single-engine SERVICE LETTER

SE72-7

SUBJECT: OPERATIONAL FUEL MANAGEMENT PROCEDURE

AIRCRAFT AFFECTED: Model 172/Skyhawk ---- 1956 through early 1970 models
F172 --- 1963 through early 1971 models

Figure 1. Fuel Selector Valve Placard Locations.

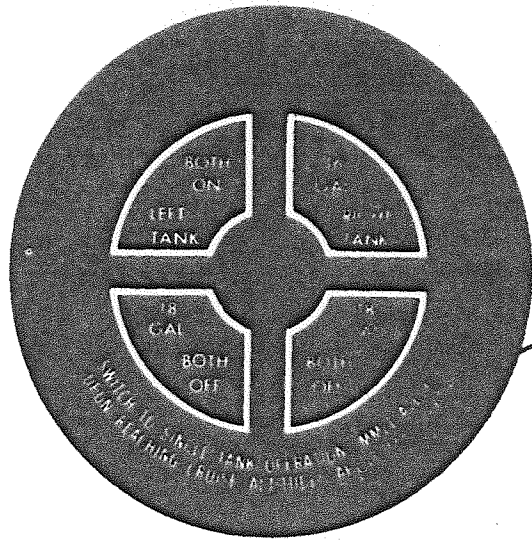
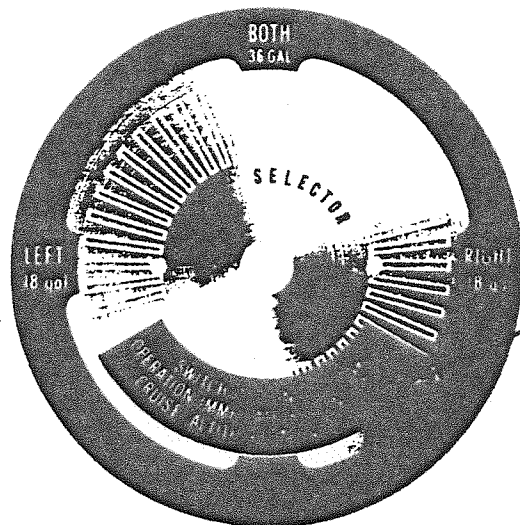
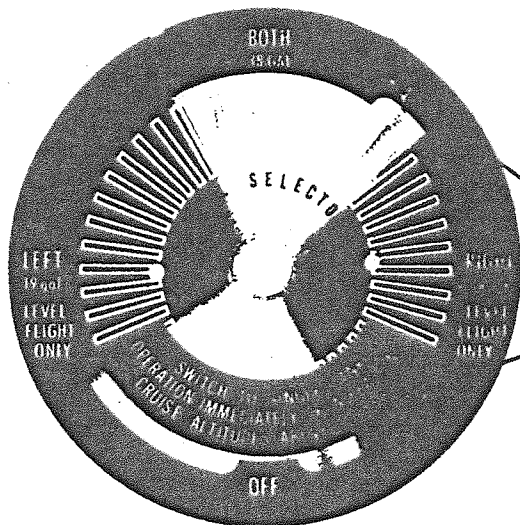
A placard, giving the following operational fuel management technique, is to be placed on the fuel selector valve.

SWITCH TO SINGLE TANK OPERATION IMMEDIATELY UPON REACHING
CRUISE ALTITUDES ABOVE 5000 FEET.

1. Owners and operators immediately affix the placard(s) to the fuel selector valve (as shown on Page 4 of this Service Letter) and adhere to the simple tank switching procedure during all future operations.
2. Owners and operators carefully study the Owner's Manual insert and affix it to the last page of Section 2.
3. Owners and operators who have experienced the symptoms of vapor or who consistently operate under conditions of high temperature, high humidity, and high altitude, install the vent kits (shown below) to eliminate any possibility of excess vapor formation.

PART NUMBER 0509021-1 PLACARD

PART NUMBER 0509021-2 PLACARD

PART NUMBER 0509021-3 PLACARD

PART NUMBER 0509021-2 PLACARD
